November 29, 1984

Cecil O. Thomas, Chief
Standardization & Special Projects Branch
Division of Licensing
U.S. Nuclear Regulatory Commission
Washington, DC 20555

The enclosed materials are submitted in support of the University of Utah's application for renewal of its TRIGA Nuclear Reactor Operating License, R-126, Docket No. 50-407.

UNIVERSITY OF UTAH TRIGA REACTOR (UUTR)

UNIVERSITY OF UTAH
Core Configuration #18

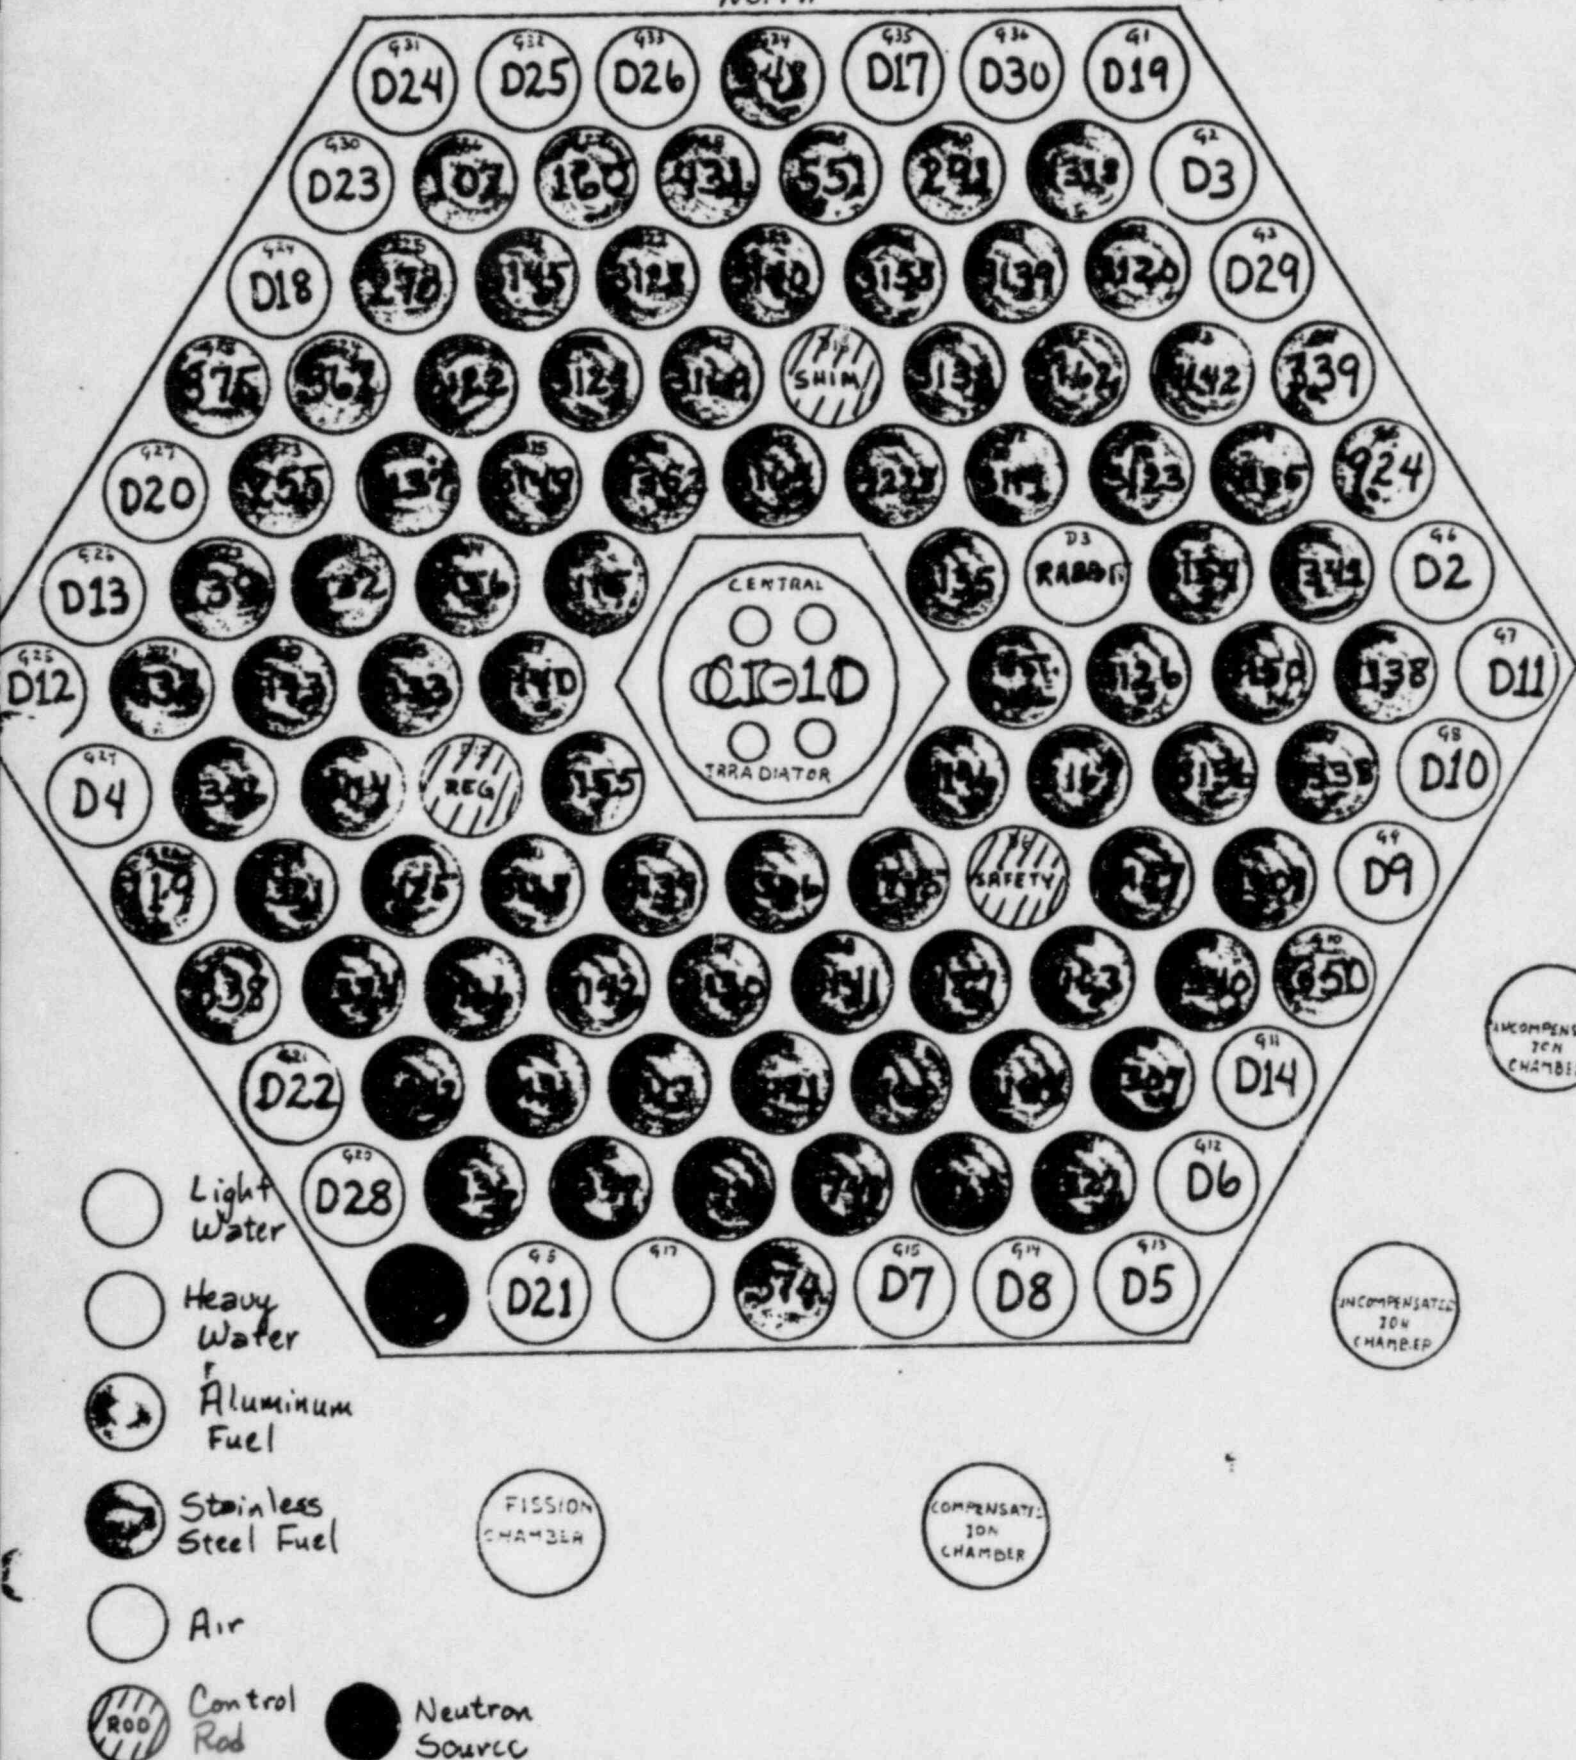
2. Provide a plan view of the current core configuration showing the number and locations of the fuel elements (differentiate between stainless-steel and aluminum elements), the control rods, the D₂O reflector elements, the D₂O reflectors tanks, the experimental tubes, the irradiation facilities, the neutron detectors, and the startup source. Also indicate how many and where (if any) the instrumented fuel elements (aluminum or stainless-steel) are in the current core and what type of thermocouples are used.

The Figure enclosed provides a plan view of the current core configuration. The single instrumented fuel element in position C3 is stainless steel clad. Three thermocouples (chromel-alumel) provide channel output for fuel/fuel temperature sensing.

Shut down : \$0.83
Excess React: \$1.18
Safety: \$1.76
Shim: \$1.55
Req: \$0.46

Reactor Tank

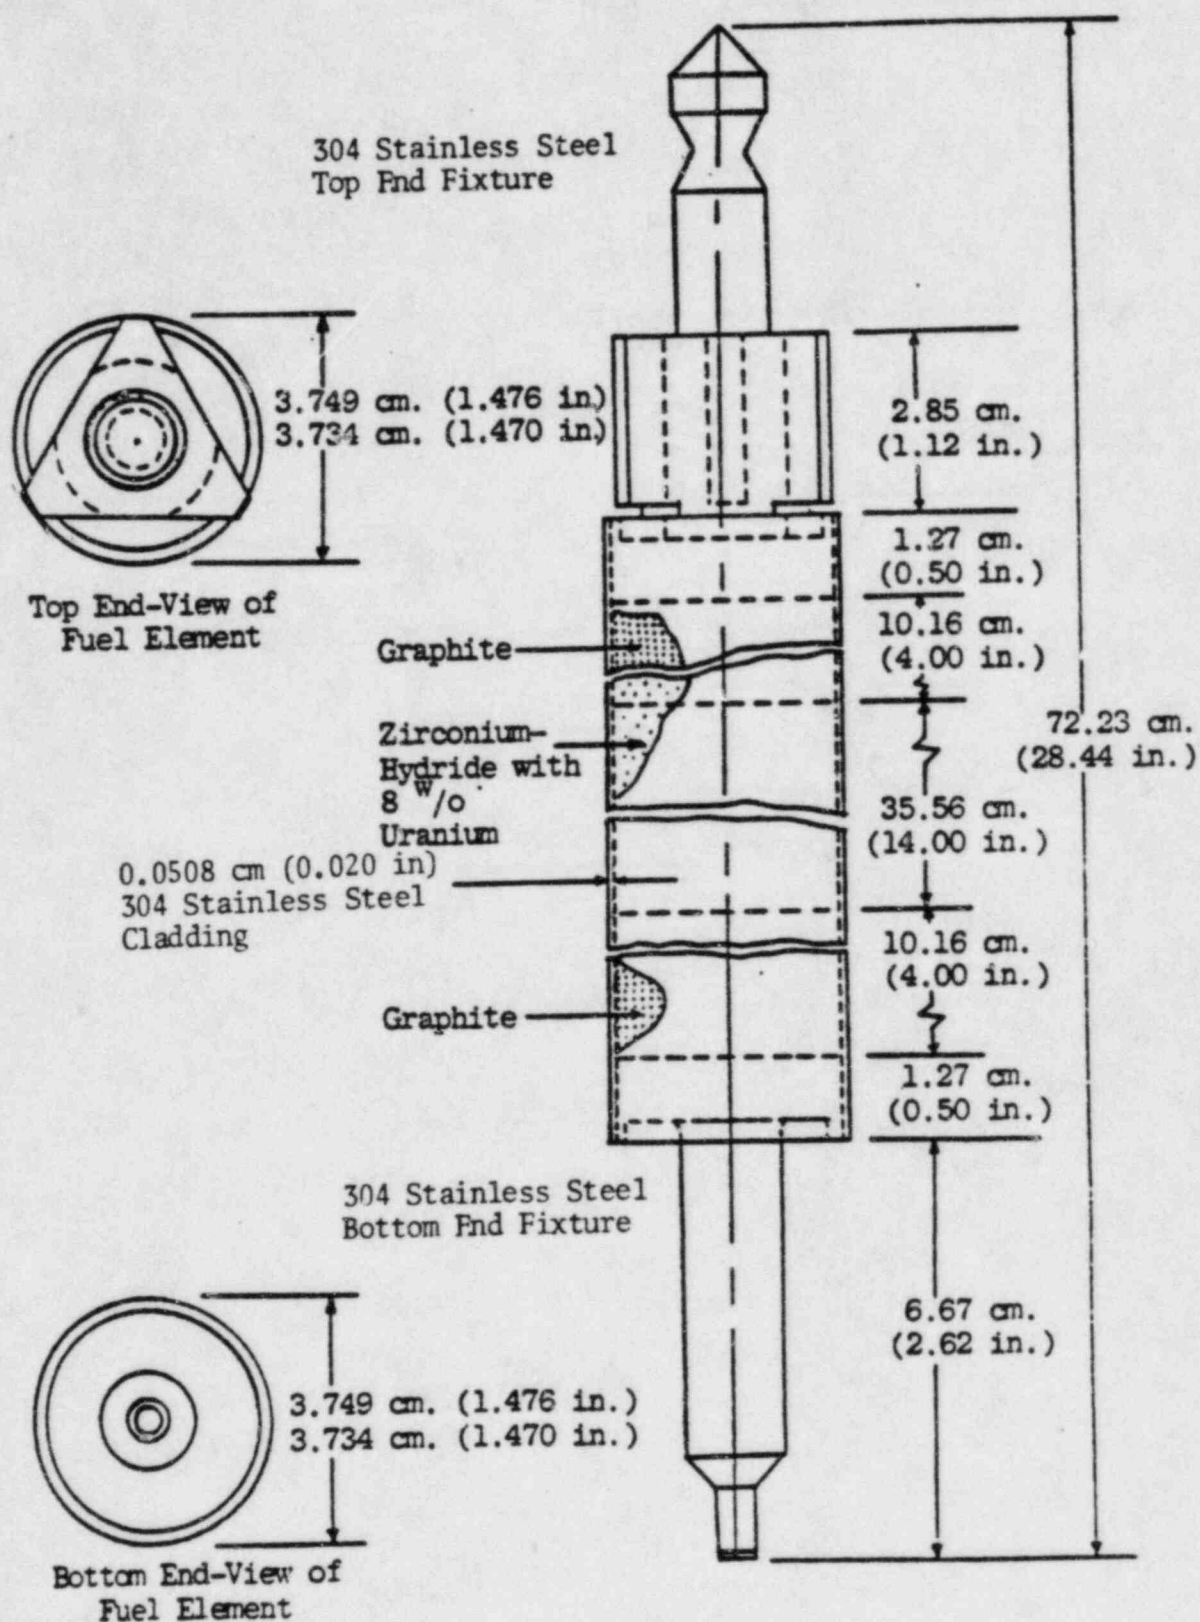
7. How many spare fuel elements are there? How many have been irradiated? Where are they stored? Describe the fuel handling tools used and fuel storage facilities at the UUTR. Give details of the current inventory of fuels in these storage areas.

There are 3 stainless clad and 45 aluminum clad fuel elements stored in the reactor tank outside the core or locked fuel storage pits. All have been irradiated (see fuel allocation table.) The fuel handling tool is the standard GA flexible cable with manual actuator which locks on the chamfered top of the element:

Stainless-Steel Clad Fuel Element

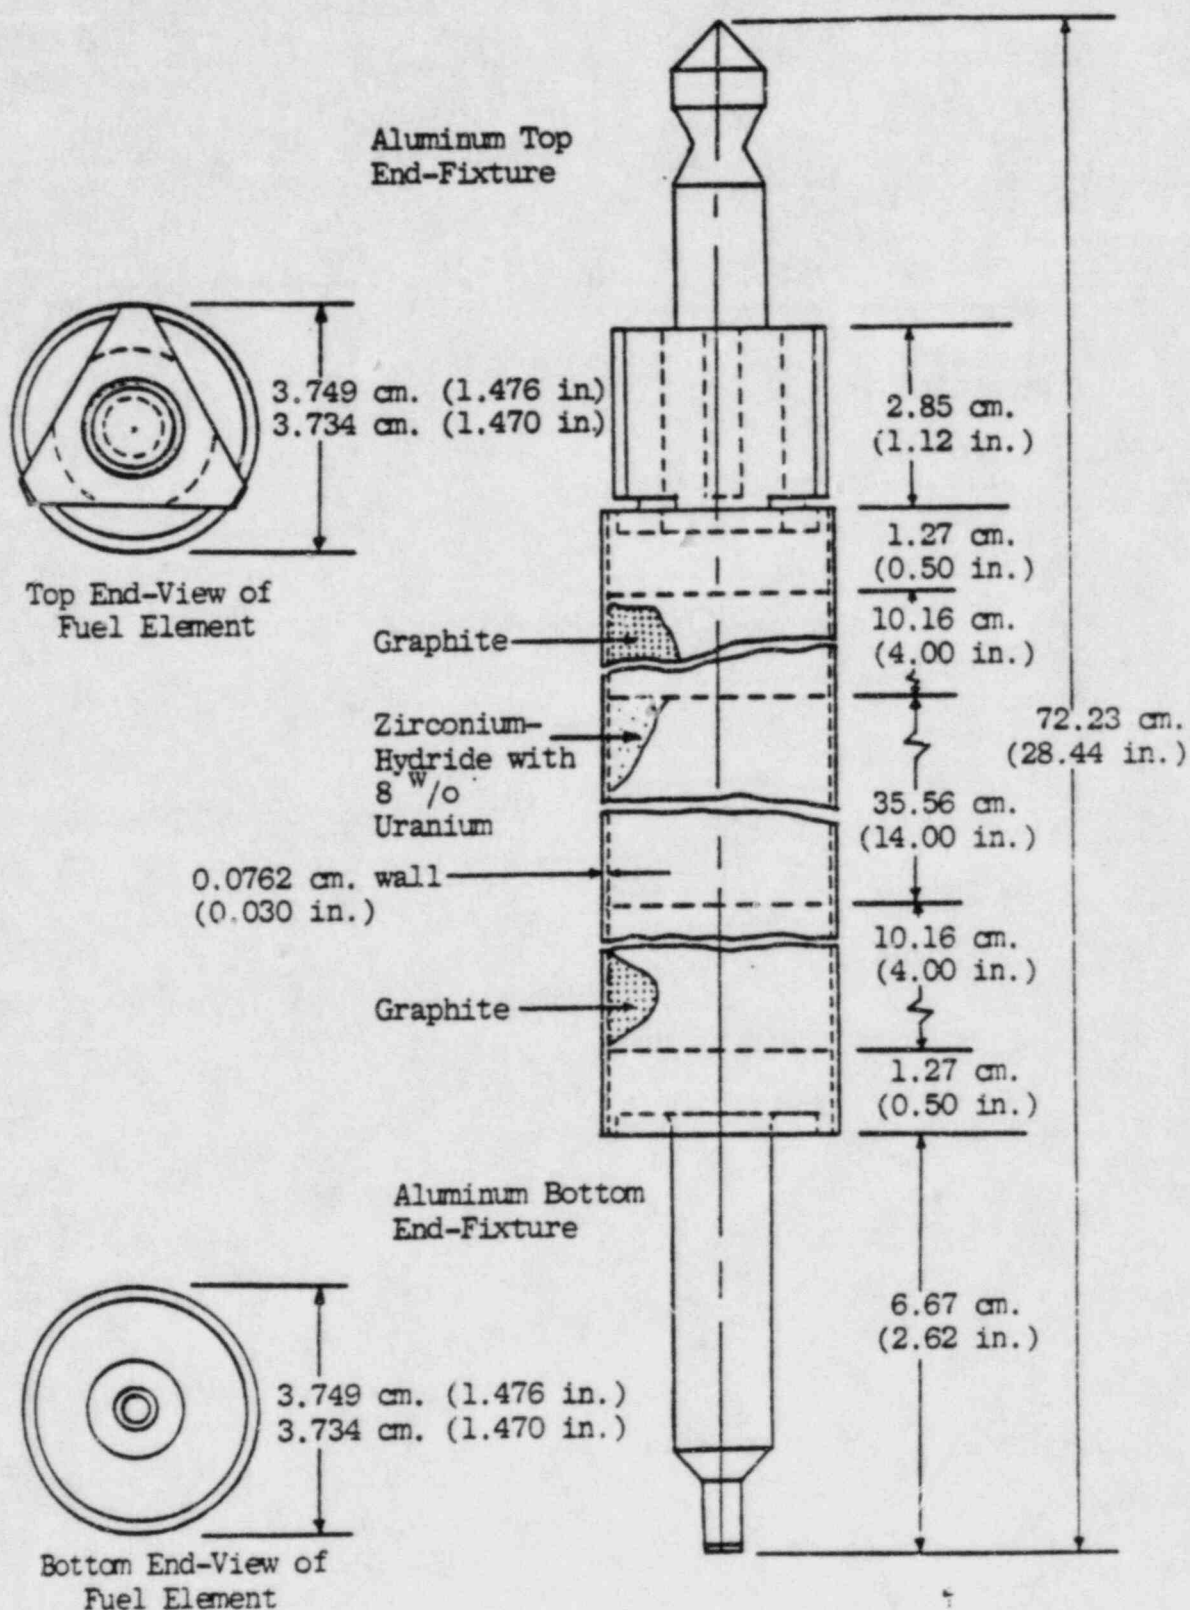
8. Provide a summary of the fuel element specifications for the stainless-steel-clad elements that are used in the UUTR. Include a schematic drawing of a stainless-steel-clad fuel element assembly.

See Attached Drawings.

Typical Source Holder

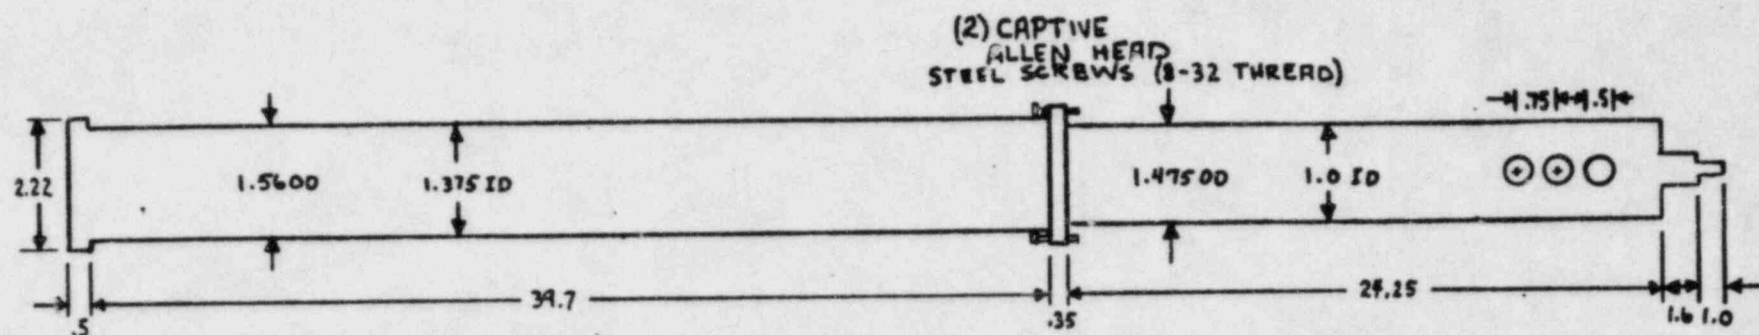
10. Provide information on the dimensions of the neutron source holder and the manipulation of the neutron source during startup and power operation.

See attached drawing. The neutron source is always located in the reactor core except when the power level of the core exceeds 1 watt of thermal power. Then the neutron source is removed from the core via a stainless steel cable attached to the source and stored during power operation in the tank wall storage rack.

CONTROL ROD MECHANISM
UNIVERSITY OF UTAH TRIGA REACTOR
NUCLEAR ENGINEERING LABORATORY

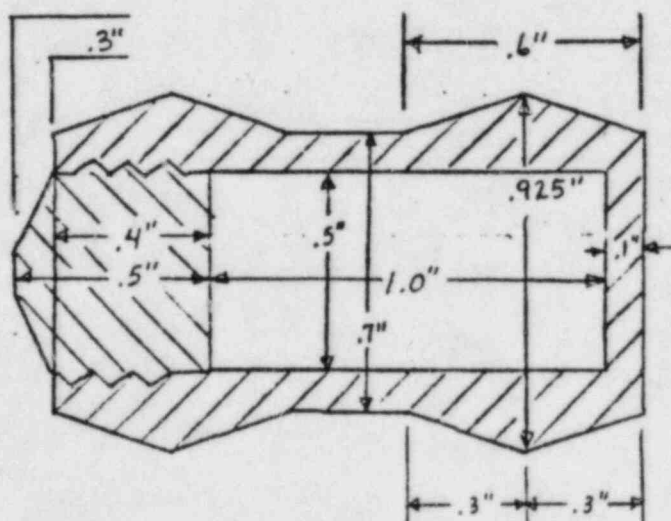
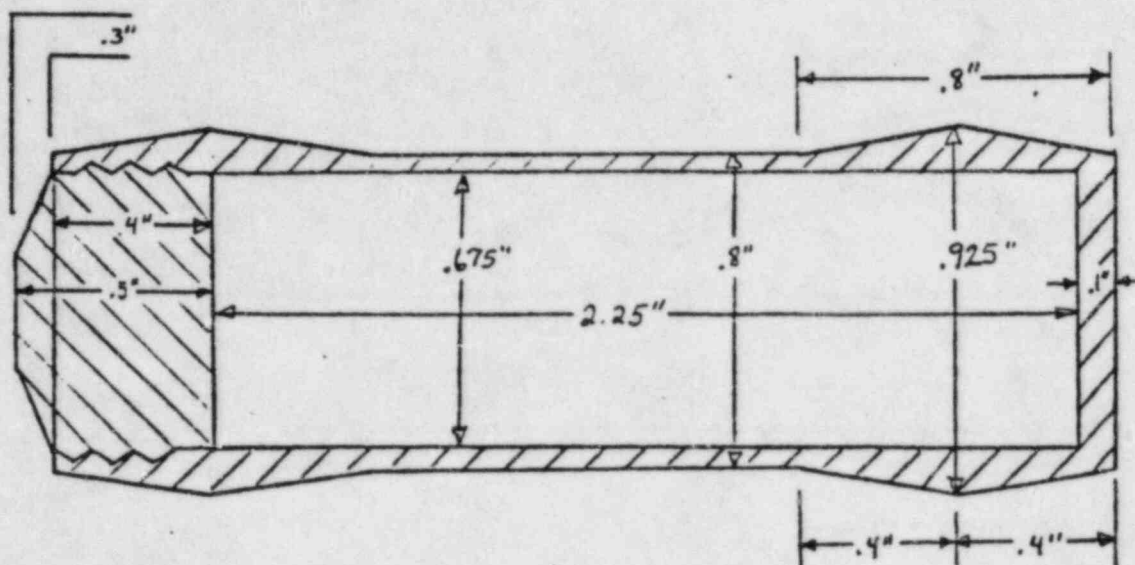
11. What is the type and form of neutron poison contained in the control rods? What are the dimensions and what is the vertical travel length of the control rods?

See figure attached. Neutron poison in control rod is boron-carbide, vertical rod travel is 15 inches.

PNEUMATIC RABBIT
UNIVERSITY OF UTAH TRIGA REACTOR
NUCLEAR ENGINEERING LABORATORY

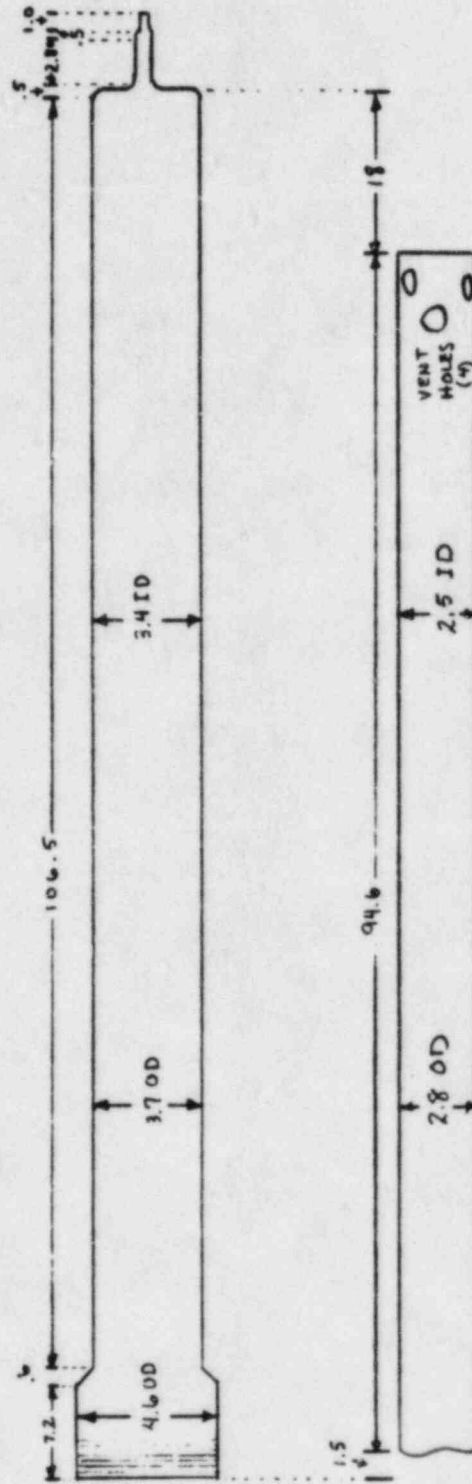
22. What restrictions are placed on the samples that are irradiated in the pneumatic transfer system? Describe the pneumatic transfer irradiation facility (materials of construction, dimensions, terminals, propulsion method, and controls).

All samples irradiated in the pneumatic transfer system must satisfy technical specification 3.6 and are always encapsulated and sealed in a polyethylene sample vial and then inserted in a polyethylene pneumatic transport vial (see figure). A detailed figure of the pneumatic rabbit is enclosed. All construction materials are aluminum except the damper spring which is stainless steel. Air is used to propel the sample in and out of the core. The control system for insertion and removal is electronic employing a time and air-value relay system. Fissile samples are not permitted to be irradiated in the pneumatic system under the provisions of the Nuclear Engineering Laboratory Operations Manual for the UUTR.

Figure 4.6.1 Ventilation System

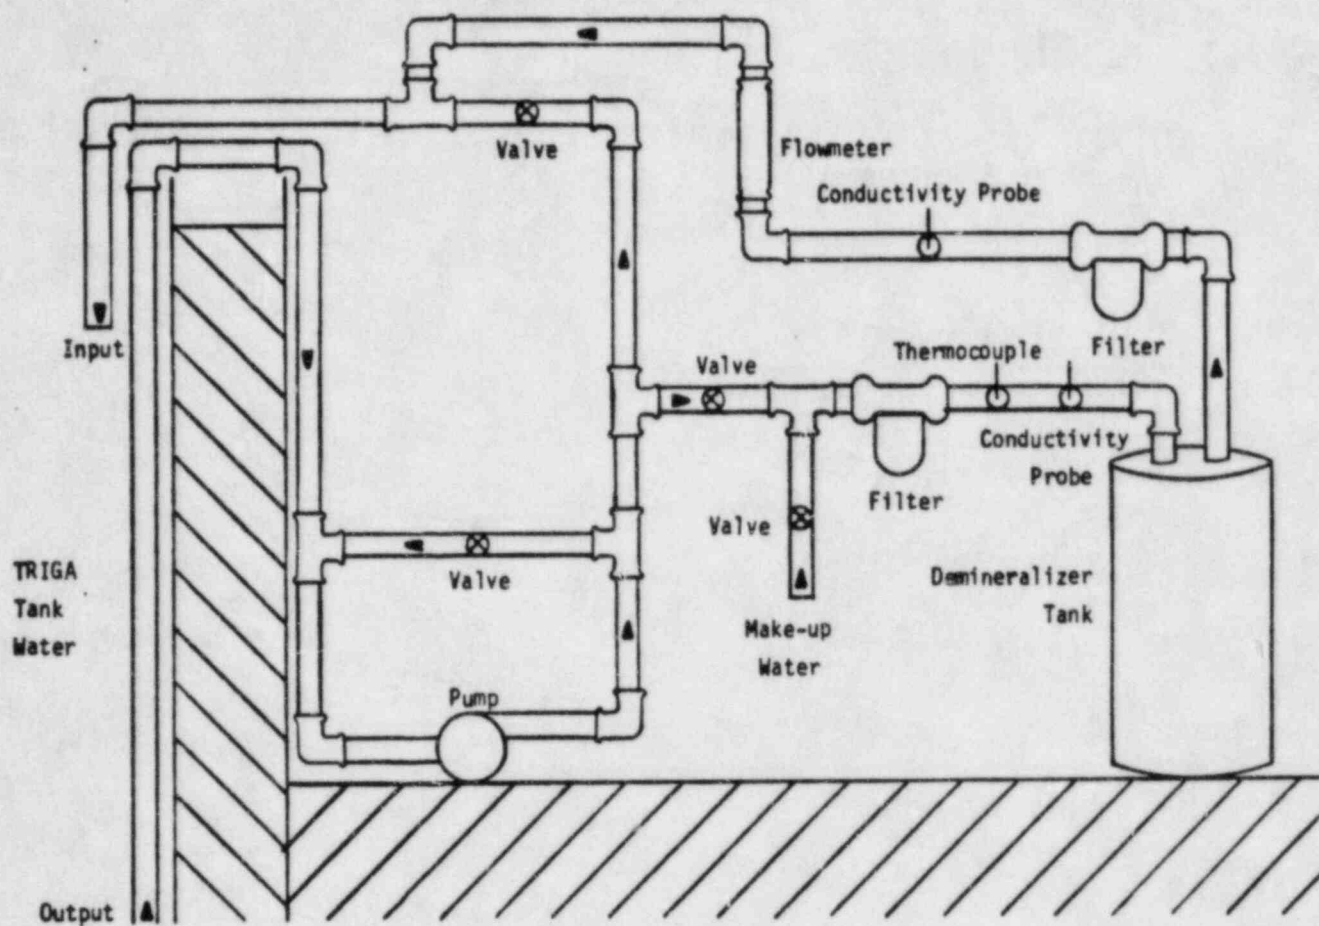
23. How is the ^{41}Ar from the irradiation of air in the pneumatic system handled.

Exhaust air from the pneumatic system is vented to the reactor room exhaust system and is monitored by the ventilation system detector. See figure for ventilation system schematic.
